Statement of Case

Regarding the Planning Application for the Curraghinalt Gold Project (Application AIL/2024/0008 and AIL/2024/0009)

Dear NIEA, Water Regulation Team

WEST POND
 Typical Operating
 Water Level = 226.0m
 Max Volume = 38,855m³

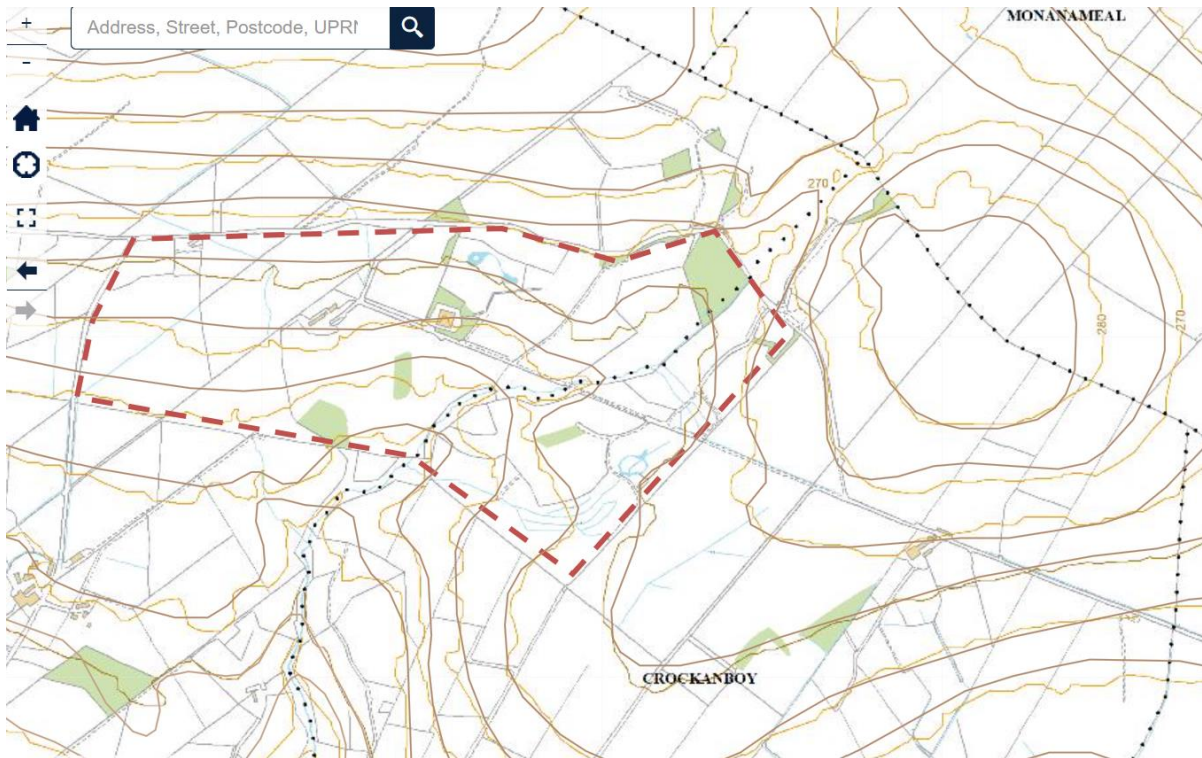
Even with this selective representation of data it can still be seen from some of the data that there is an elevational difference along the East – west viewpoint. Please see below for West Pond

It can clearly be seen here that even with the selective representation of data it is still impossible to hide the fact that water levels will be higher than the surrounding natural ground level. The fact that these ponds contain immensely above volumes of 10,000 cubic meters on the side of a hill would clearly represent that they are indeed falling under the legal framework of the Reservoirs Act (Northern Ireland) 2015.

Figure 2 – 229.0 meters highlighted in Yellow for west pond

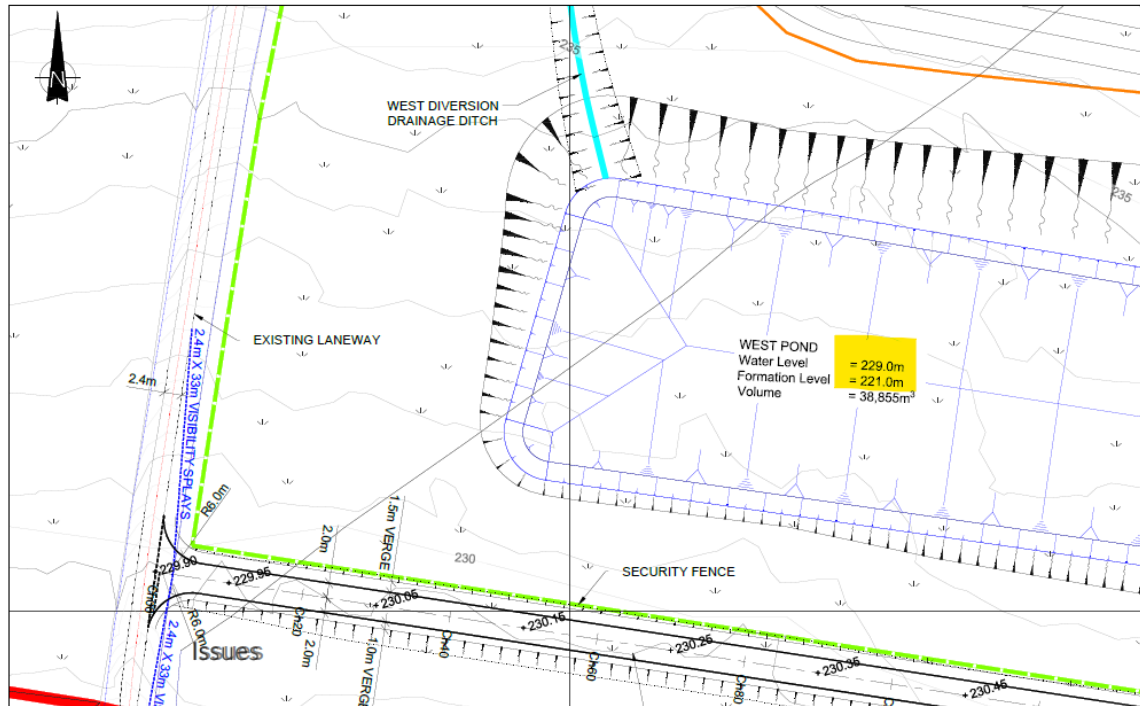
This is in reference to maps which would give a full overview of the project, and its impoundment ponds as can be seen in UPDATED ES (2) Vol 3 - App B12 - Design Drawings - 10 of 18 - Received 04.11.2020 page 7 of 14 where instead of giving water levels it gives formation levels.

If the same map is taken with the detail given in the below illustration taken from the same document but on page 9 of 14 it would make for far more concerning and different reading, as it can be seen the water level is sitting at 229m this data with a ground level in the immediate area sitting at 225.453m, which clearly and unarguably demonstrates these reservoirs fall under the reservoirs act.
